NORTH ANNA POWER STATION

Section 3.2 Power Distribution Limits

Improved Technical Specifications

**NORTH ANNA POWER STATION
IMPROVED TECHNICAL SPECIFICATION CONVERSION**

Figure B 3.2.18-1 (page 1 of 1)
 K(Z) - Normalized $E_0(Z)$ as a Function of Core Height

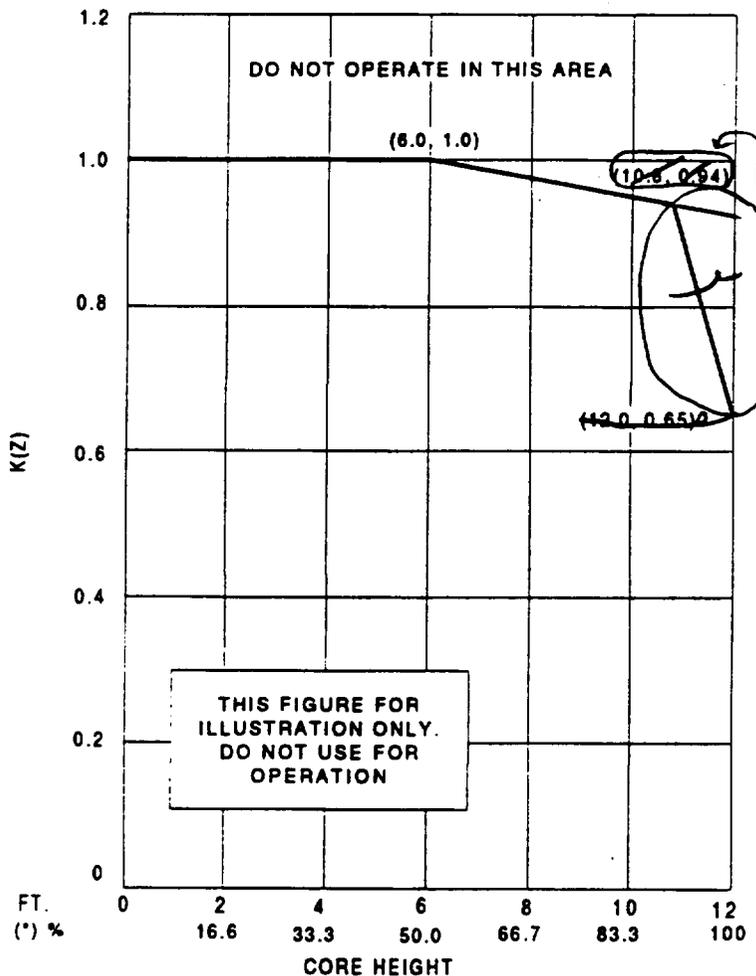
For this facility, the actual values of CFQ (and K(Z)) are given in the COLR; however, CFQ is normally a number on the order of 2.32 and K(Z) is a function that looks like the one provided in Figure B 3.2.13-10

1. The Bases are revised to reflect the Relaxed Power Distribution Control (RPDC) methodology and changes made to the ITS to implement that methodology.

Figure B 3.2.38-1 (page 1 of 1)
AXIAL FLUX DIFFERENCE Acceptable Operation Limits
as a Function of RATED THERMAL POWER

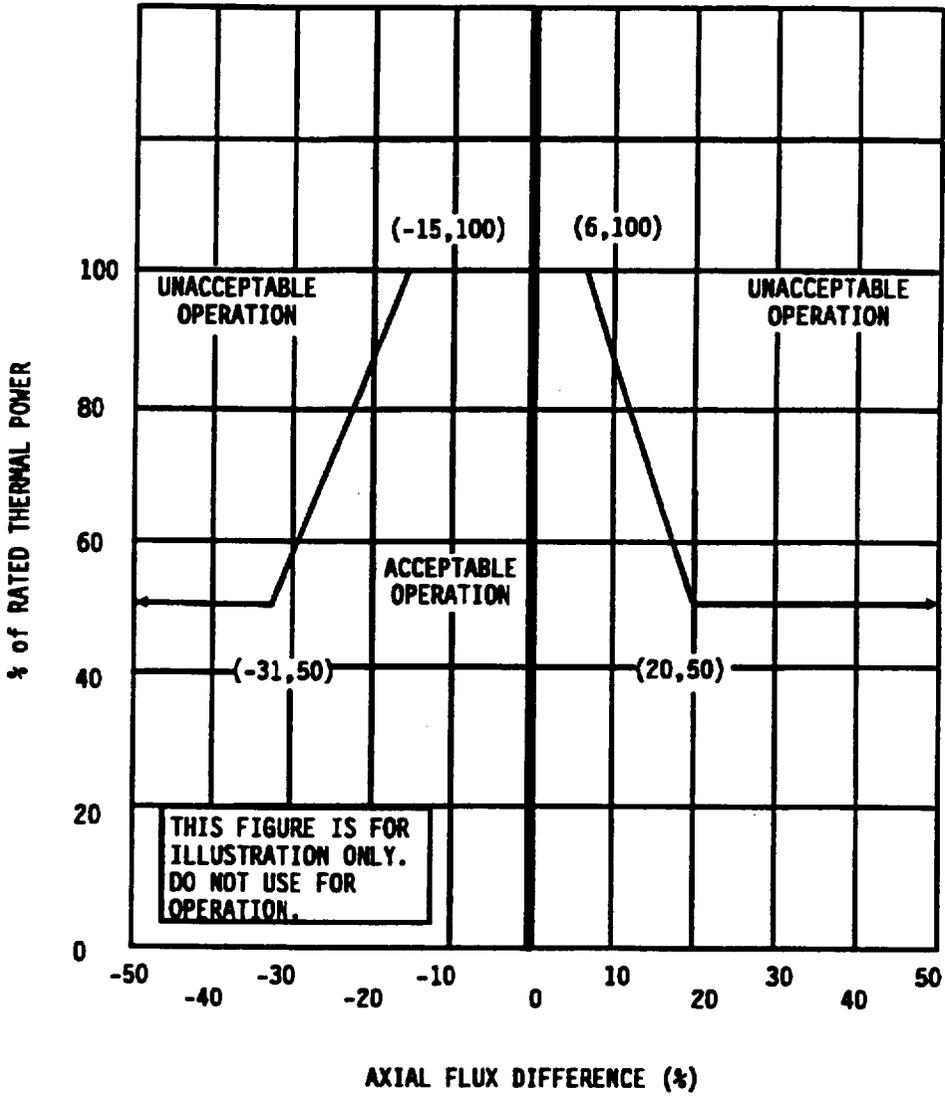
The AFD limits are provided in the COLR. Figure B 3.2.38-1 shows typical RAOC AFD limits. The AFD limits for RAOC do not depend on the target flux difference. However, the target flux difference may be used to minimize changes in the axial power distribution.

1. The Bases of ITS 3.2.3B, AFD (RAOC Methodology) is revised to reflect the Company Relaxed Power Distribution Control (RPDC) methodology and associated FQ Surveillance Technical Specifications approved by the NRC in VEP-NE-1-A, March, 1986. Terminology, descriptions of analytical methods, and references are changed as needed.

3. ITS ITS 3.2.3A, AFD (CAOC Methodology), Bases are deleted. ITS ITS 3.2.3B, AFD (RAOC Methodology) is used as the model for the North Anna ITS.
4. The brackets have been removed and the proper plant specific information/value has been provided.
